CONTRACT CHANGE ORDER NO. 17451
SHEET 3 OF 9

MARK	DATE	DESCRIPTIONS	BY	CH'D	CCO#
0	02/08/13	ADDITIONAL MISCELLANEOUS ELEVATOR DETAILS	JB	AE	17451

SAN FRANCISCO OAKLAND BAY BRIDGE
EAST SPAN SEISMIC SAFETY PROJECT
SELF-ANCHORED SUSPENSION BRIDGE
(SUPERSTRUCTURE & TOWER)

TOWER ELEVATOR ENCLOSURE DETAILS NO.2

TOWER ELEVATOR ENCLOSURE DETAILS NO. 7

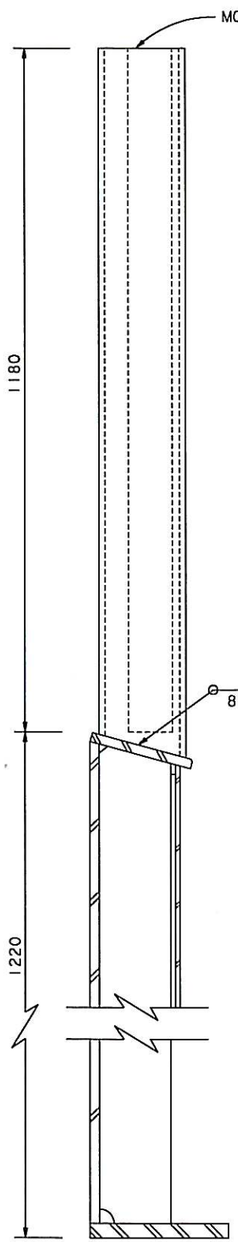
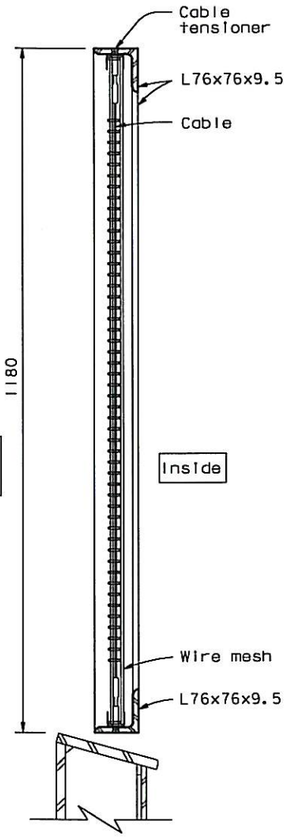
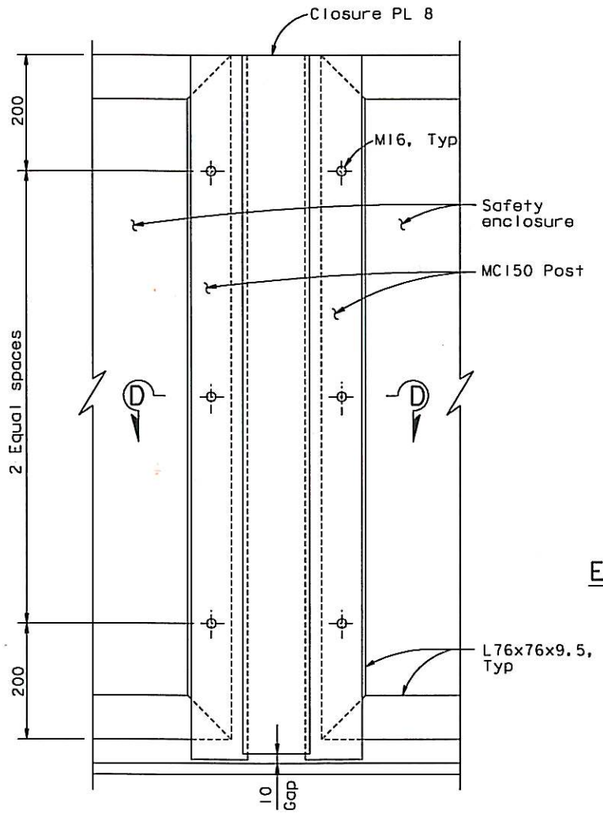
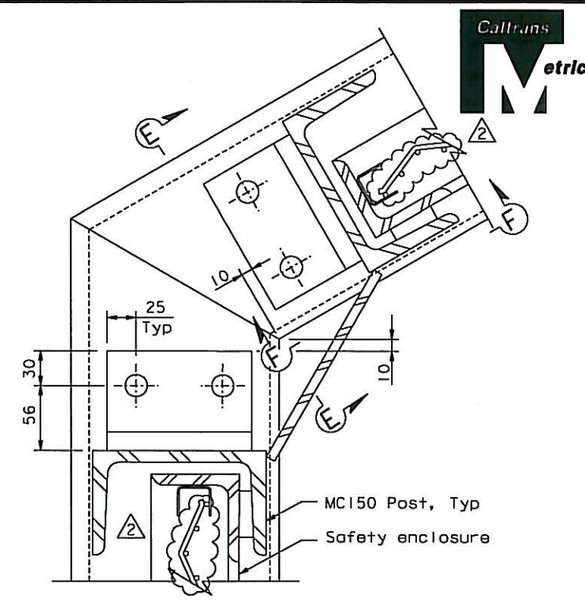
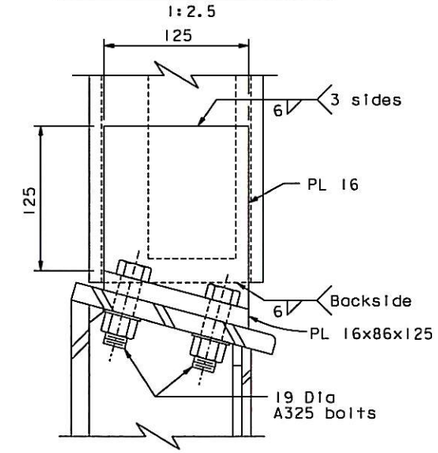
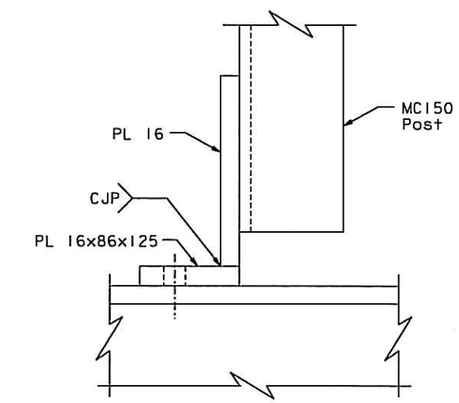
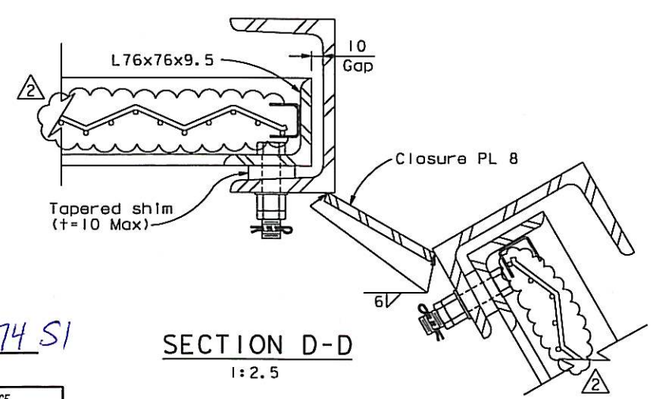
1. For enclosure details not shown, see "Tower Elevator Enclosure Details No. 2" sheet.
2. At the Contractor's option, Enclosure Screen Bolted Alternate Detail may be used in lieu of fillet weld.
